# Bend in the Bow.

Design Development Plan  
Phase 2: Pearce Estate Park

What We Heard #3:  
Preferred Concept Option  
September 2016

Figure 2: Preferred concept for Phase 2 presented during engagement for feedback

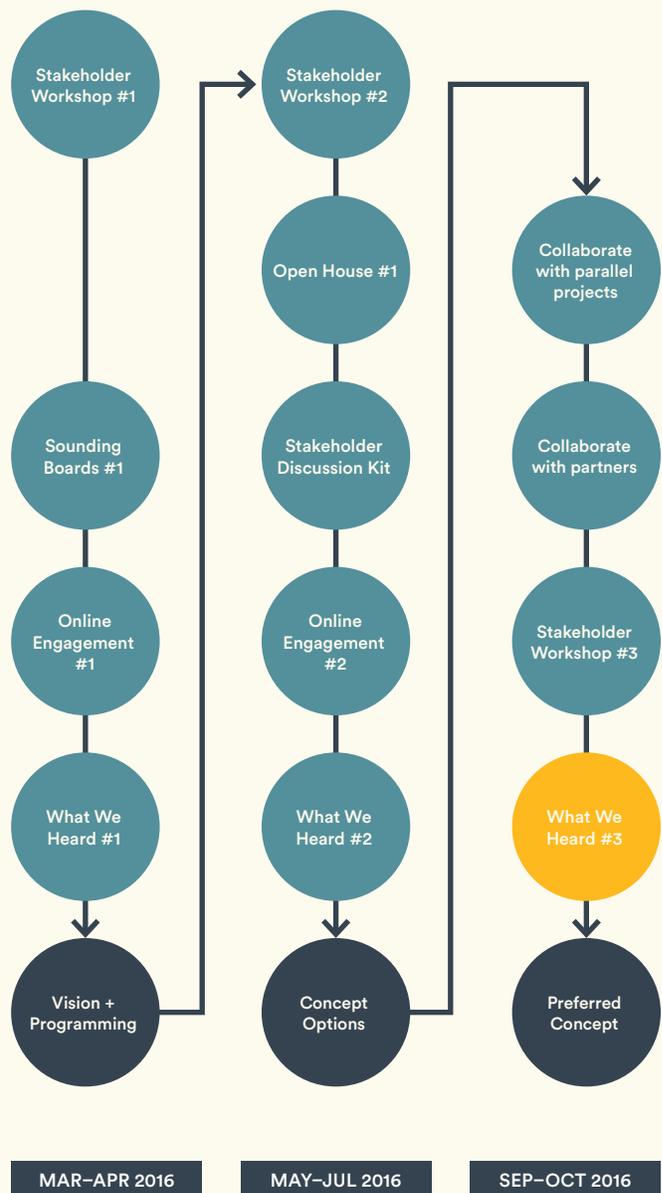
Overall, the preferred concept that was presented was well supported by the various stakeholders groups in attendance.

What We Heard		What We Heard		
<b>Berm</b>	Creates good delineation of space, barrier between natural & active use	<b>Active Use</b>	Support to redevelop green space south of Blackfoot Trail and opportunity for new active use features	
	Support for natural plantings on one side		Consider: Winter use (skating, ski paths)	
	Consider: Moving farther back where possible to preserve more natural space		Pearce Estate Park is not an appropriate site for a disc golf course	
	Provide background/rationale		Consider: Use cultural features as buffer between active & natural zones	
Consider: Safety, views, accessibility		<b>Paths</b>	Support simplified paths & wayfinding	
 Consider: Opportunity to create specific habitat & strengthen corridor; Tunnels for wildlife to cross berm to wetland; Tobaganning on multi-use side			Strengthen east-west pedestrian connections north of SoBow	
			Path not required on top of berm or in picnic area

<b>Wildlife Corridor &amp; Habitat</b>	Support for enhanced wildlife corridor, protecting natural areas, and passive restoration	<b>Pearce Memorial</b>	 Consider: Critical review of existing trail locations	
	 Consider: Island as wildlife refuge corridor; Or for recreational access		Reconsider location & message in overall Pearce story	
	Underpass: Screening at underpass to stop wildlife access to road	 Consider: Traditional style, rather than modern interpretation	<b>Interpretive</b>	Water: Include the history & impact of water throughout the site (irrigation, flooding, drainage, recreation)
	 Consider: Vegetated or art opportunity for screen; Knock out embankment to widen corridor			Transportation heritage: First Nations routes & train lines
	Preserve biodiversity			Interpretation should be integrated and dynamic (more than signage)
	 Consider: City-wide biodiversity study; Identify species using the corridor			 Support for interpretive signage in wildlife corridor

Consider bank swallow habitat			
 Support for no light along corridor/ regional trail
